Public Market - Parcel B

Emeryville Planning Commission Hearing

JANUARY 24, 2019

Design Changes

SOUTH STOREFREONTS

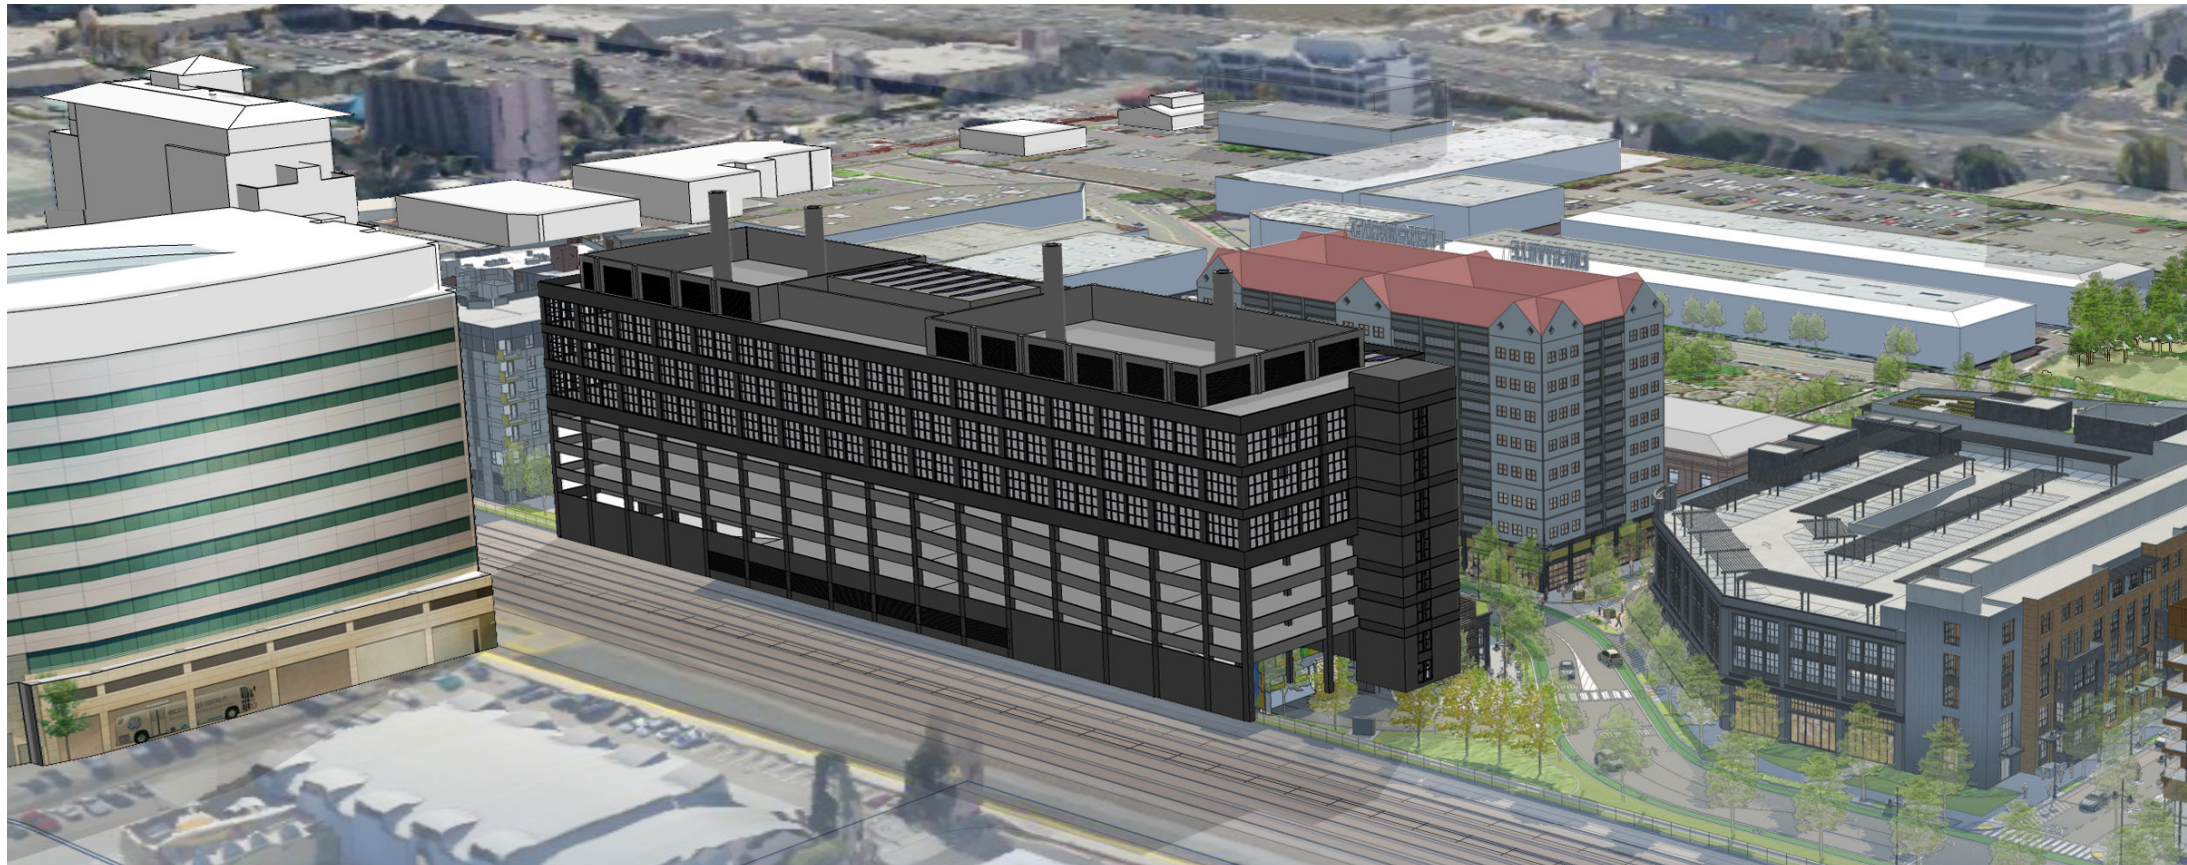
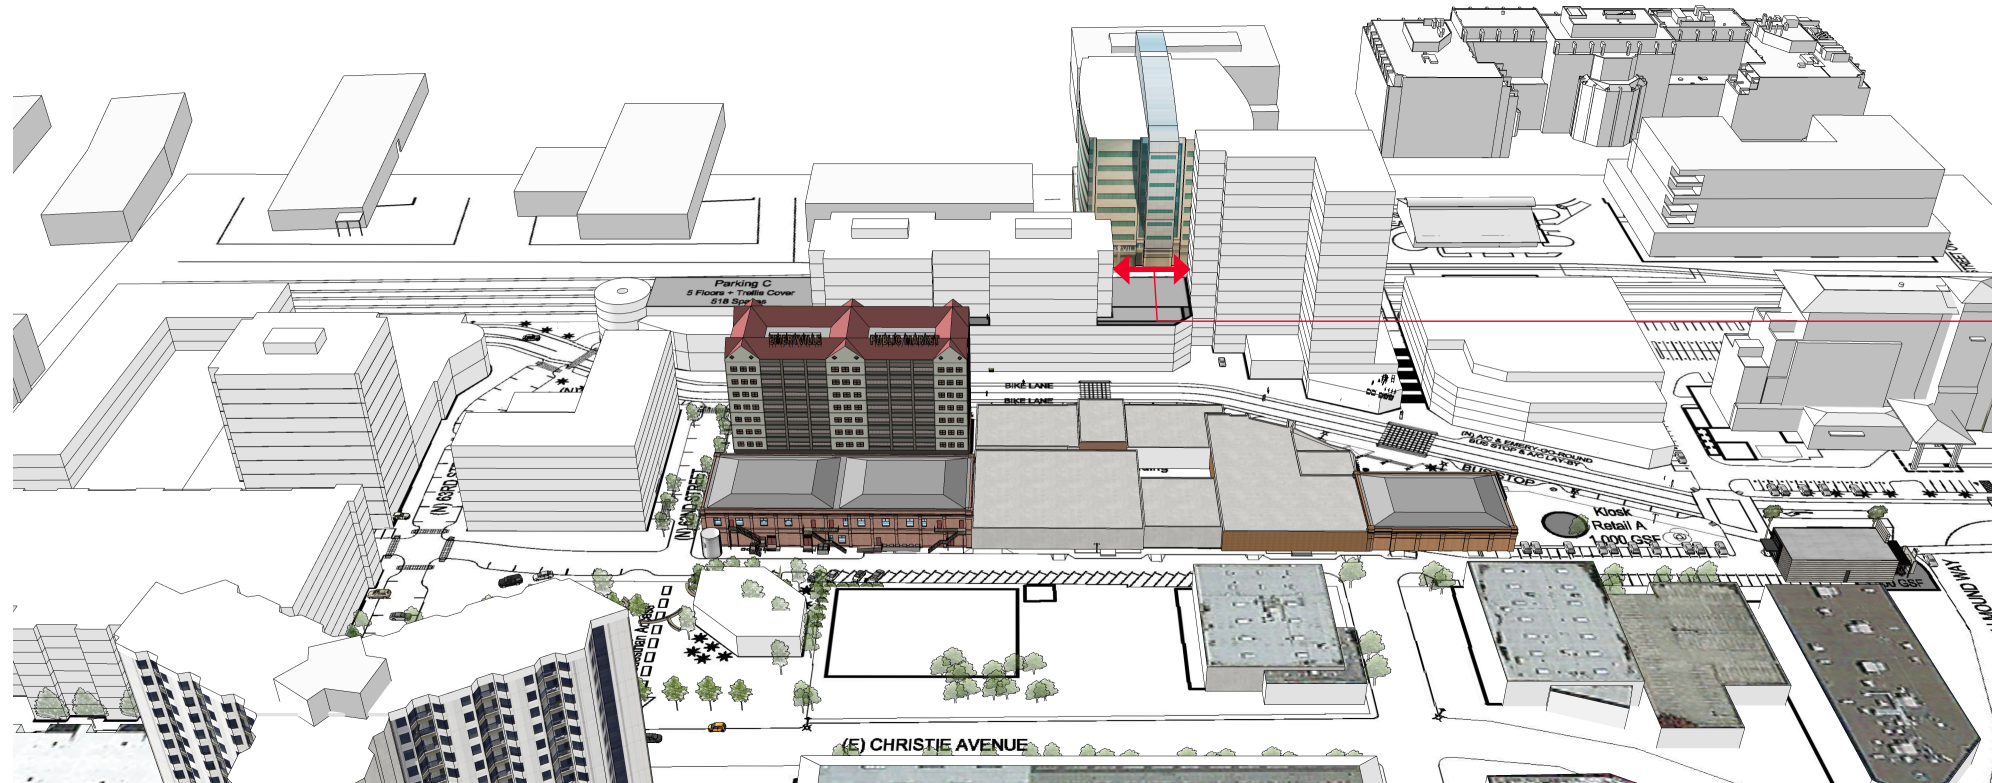
- 1. Consider adding solar/PV panels
- 2. Consider adding EV parking spaces
- 3. Provide servicing to retail areas from the back
- 4. Treat the West and East facades as equivalent fronts
- 5. Develop the Vertical circulation towers and add windows to the stairs
- 6. Develop the landscape design
- 7. Provide more detail on the retail storefronts

- 1. Building base design revised, including cornice added at top of base
- 2. Storefront design revised
- 3. Horizontal and blade signage illustrated
- 4. Lighting added
